### **Lexington Planning Board**

Thursday, May 24, 2018 Hudson Room, Cary Memorial Building, 1605 Massachusetts Avenue 7:00 PM

DEFINITIVE PLAN
BALANCED HOUSING RESIDENTIAL DEVELOPMENT
443 LINCOLN STREET
LEXINGTON, MASSACHUSETTS
FEBRUARY 20, 2018

# TOWN OF LEXINGTON PLANNING OFFICE

SHEET No. 10 OF 11 PROJECT No. SM-5676

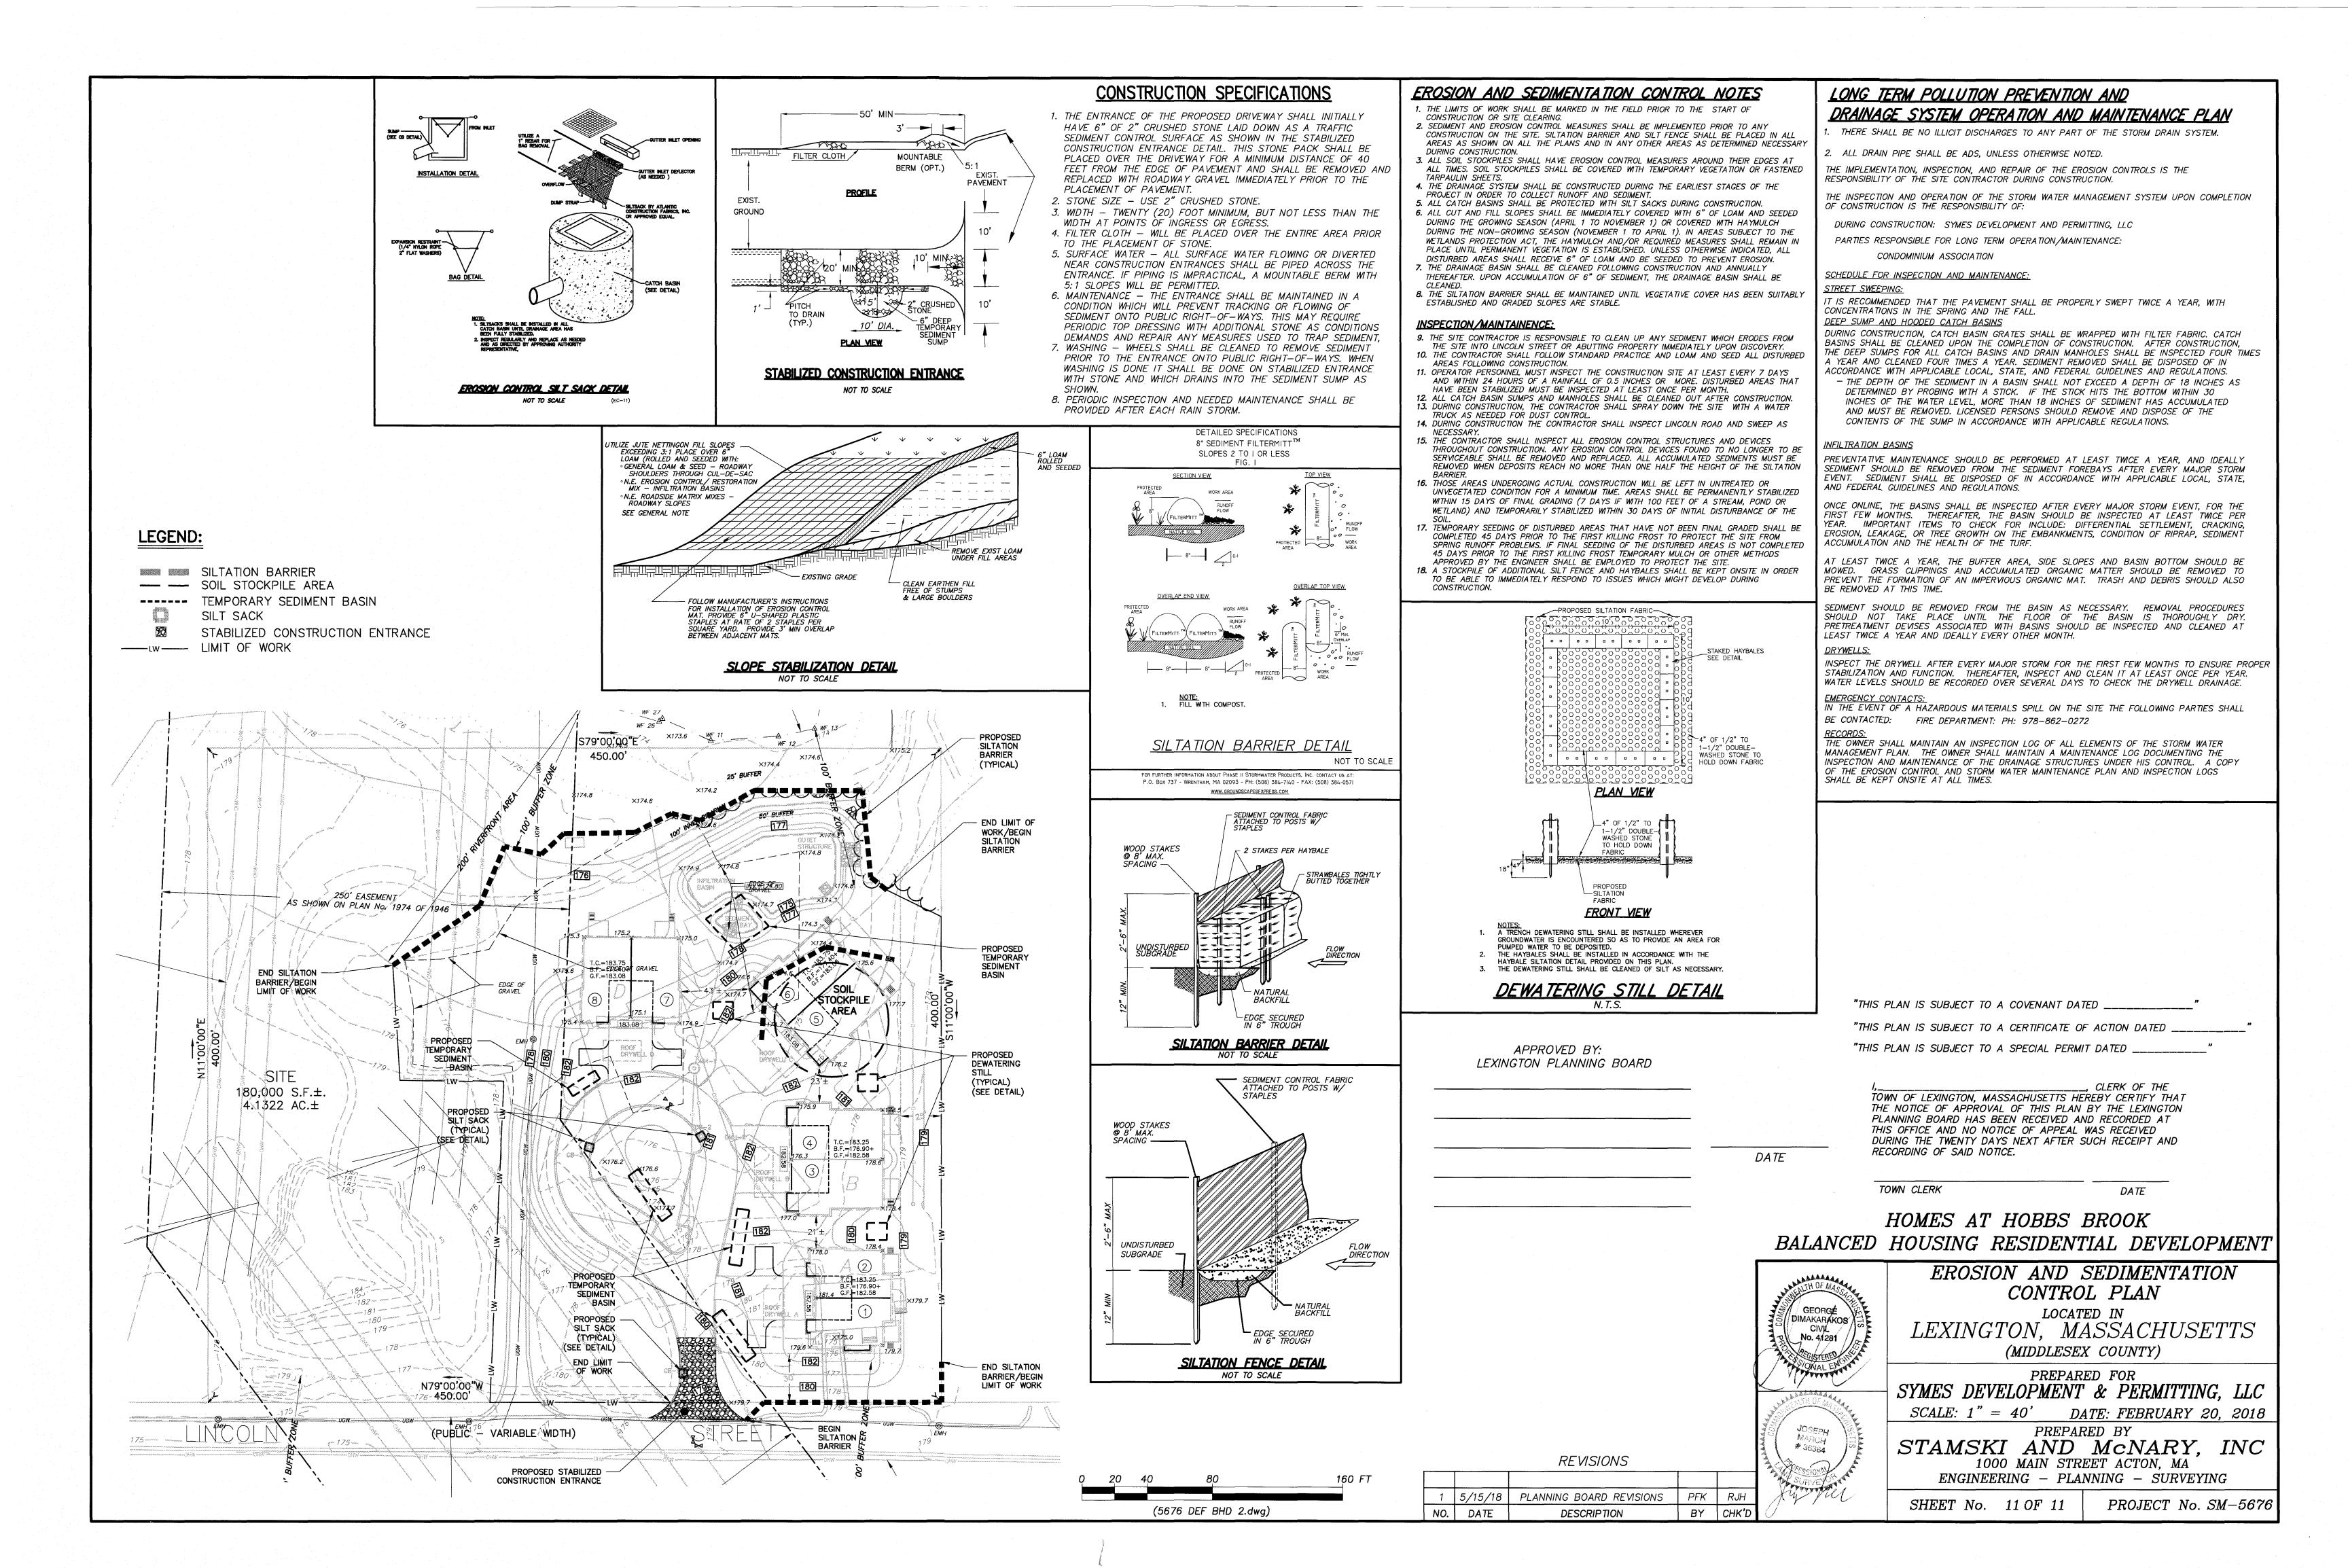
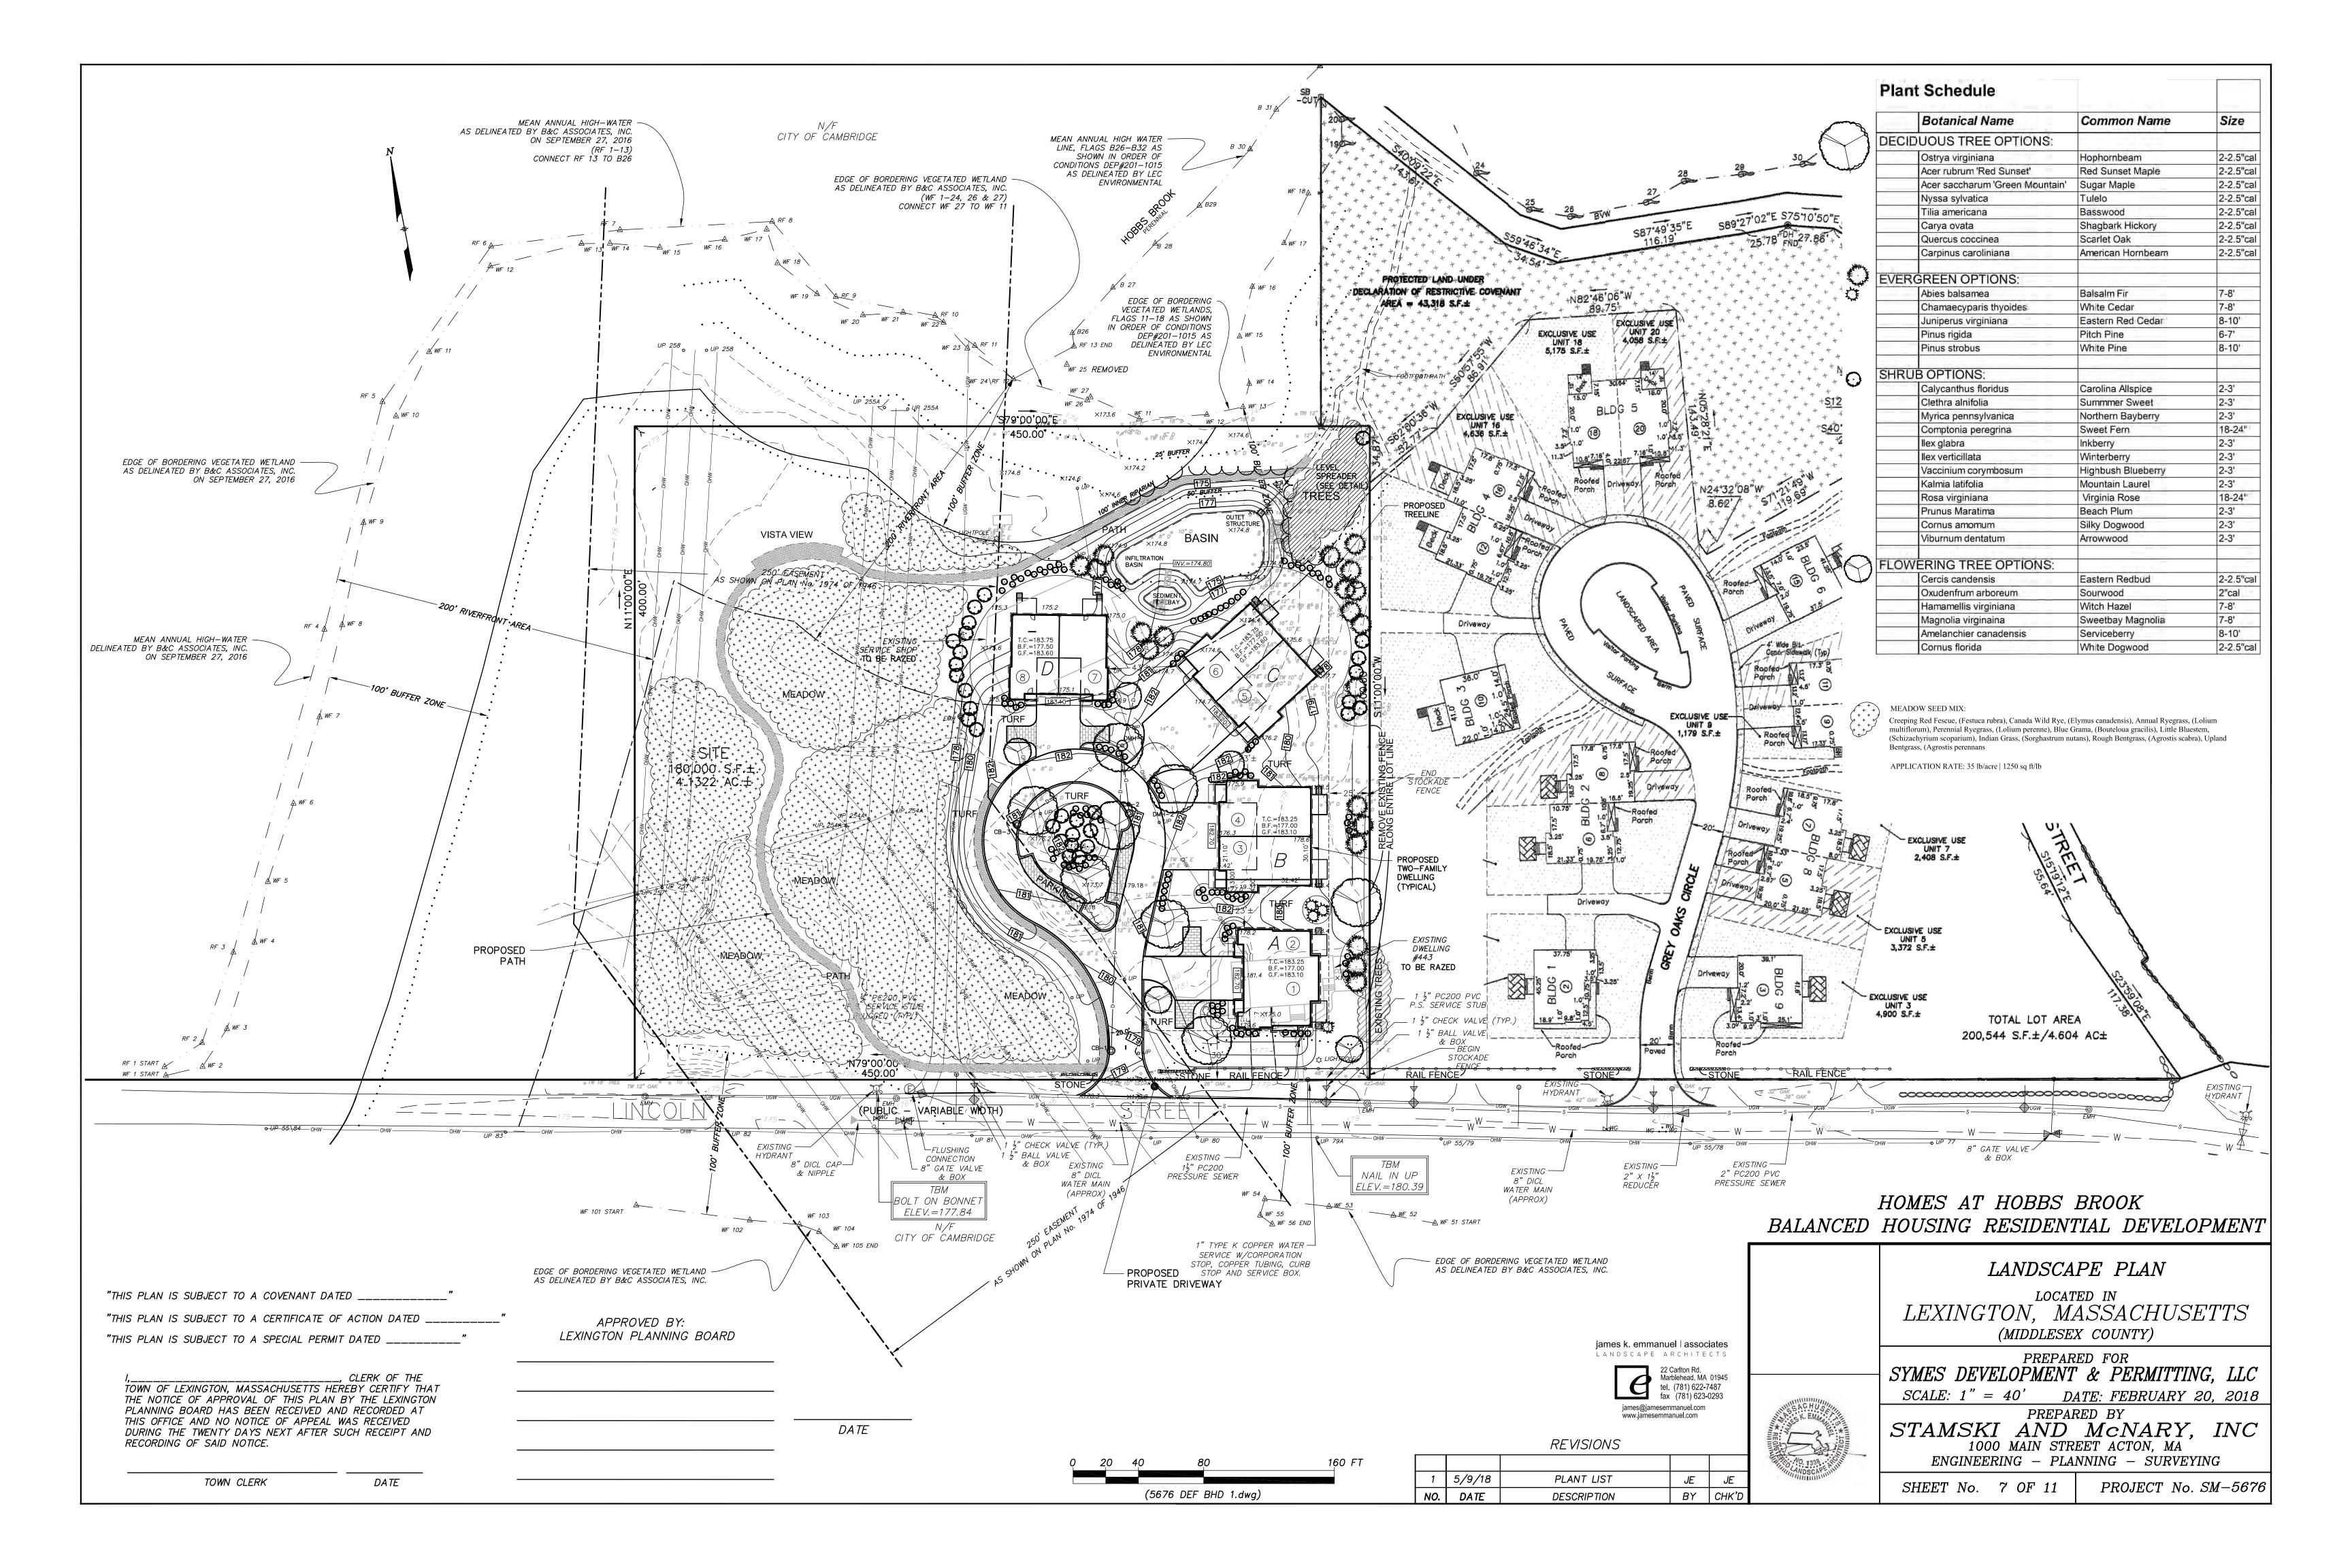
- Hydrants shall be American-Darling 5 ¼ inch B-84-B-5. Hydrant color; should conform to Lexington Fire Dept rules. We require this information be clearly noted on the plans.
- All hydrants, valves and valve boxes shall be American made only. Valves shall open **right** (**clockwise**), **hydrants shall open right** (**clockwise**). We require this information be clearly noted on the plans.
- All proposed vertical and horizontal bends for the proposed water main shall be on plans with adequate restraining glands, rods and thrust restraints.
- Please identify locations of any bends in the water main, bends will require restraints in accordance with town standards.
- An effort should be made to reduce the amount of clutter on plans so the proposed water services can be clearly identified. Will make addition comments after review of revised plans.

- The fire hydrant detail has been modified to call for use of American-Darling 5 ¼ inch B-84-B-5 to be painted per town requirements (sheet 10).
- General Note 4 has been modified to specify that all hydrants, valves, and valve boxes shall be American made only (sheet 9).
- Bends in the proposed water main have been identified (sheet 6) and thrust block specifications are provided per detail (sheet 10). The proposed water main has been relocated under the proposed access drive (sheet 6).
- A larger, 1"=20' scale, utility detail has been provided (sheet 6).

- Sewer details and inverts updated (sheet 10). Also see F.R. Mahony report.
- See F.R. Mahony report relative to existing line and services.
- General Note 18 has been added to specify that the proposed sewer system will be privately owned and maintained and a sign with contact information will be placed on each pumping unit (Sheet 9).

• Stormwater details relative to catch basins, drain manhole, area drain and level spreader have labels which have been edited per engineering comments (sheet 10).
